**Project Name: Runway 3/21 Extension – Jurisdictional Waters Mitigation  
At San Antonio International Airport (Olmos Basin)**

**Project No. 33-00160**

**Addendum No. 1**

**SECTION 31 9000  
CONSTRUCTED RIFFLES AND STREAMBED MATERIAL**

Salado Creek  
Dead Tree  
Stump Site

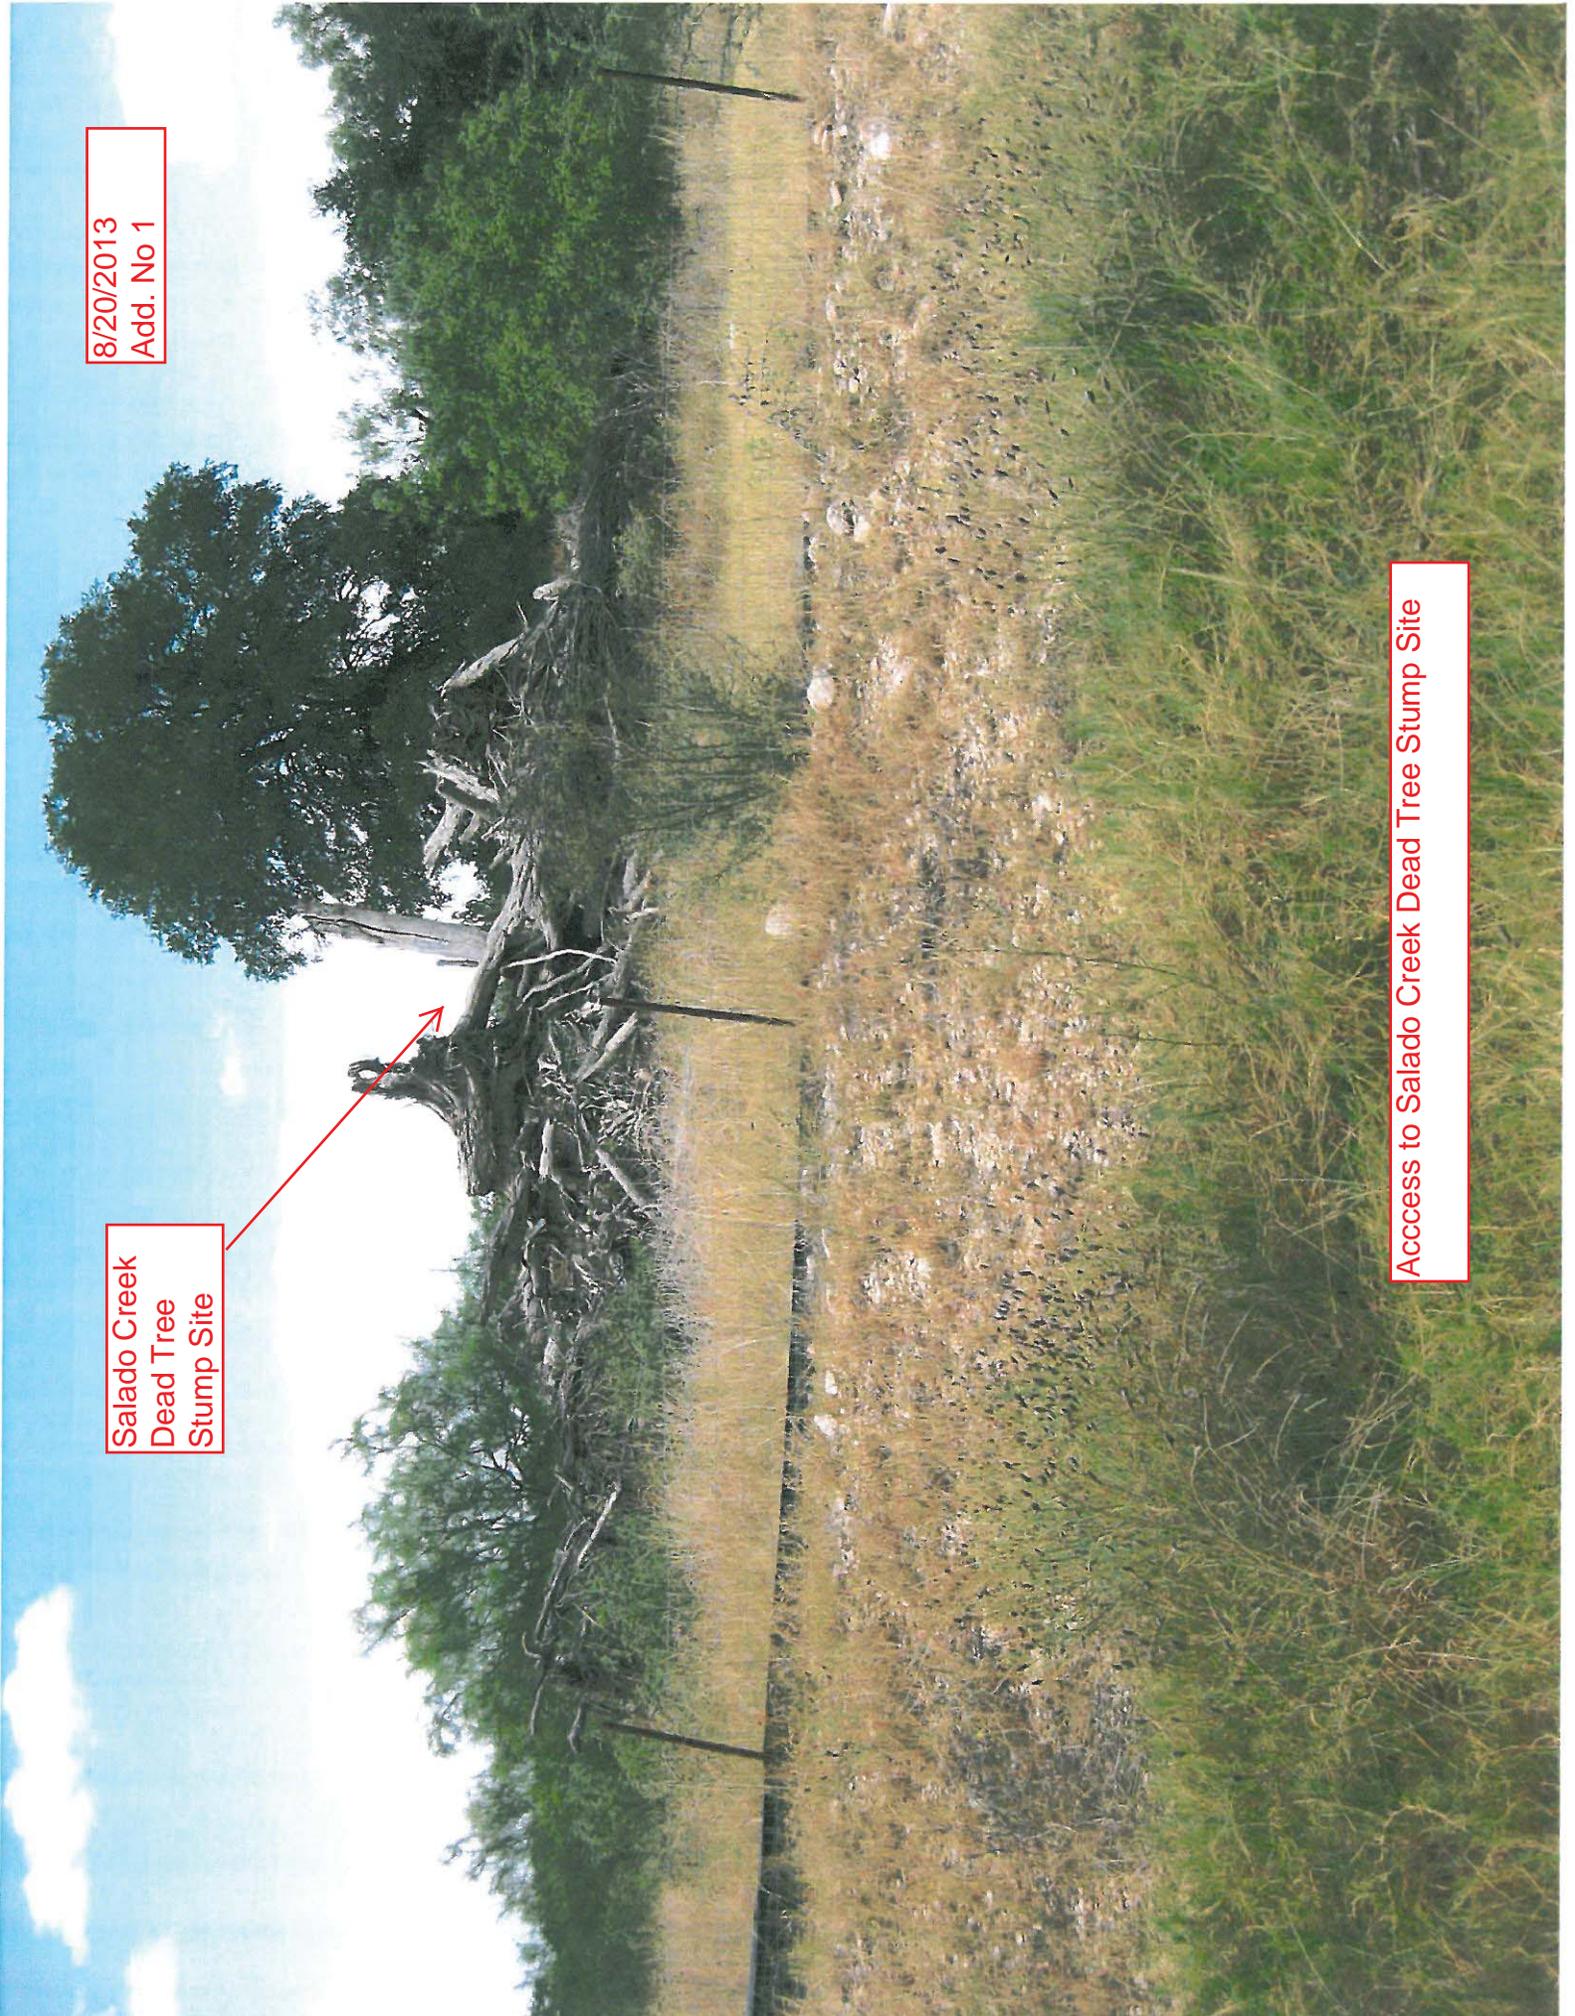
Grade control logs will be cut from trees that are removed and salvaged from the stream banks and floodplain along Salado Creek (within the Airport Runway 3-21 Extension site). The logs will be 12 - 18 inches in diameter and cut to a length of 20 - 25 feet.

Information concerning the location, access and transportation requirements for the logs are as follows:
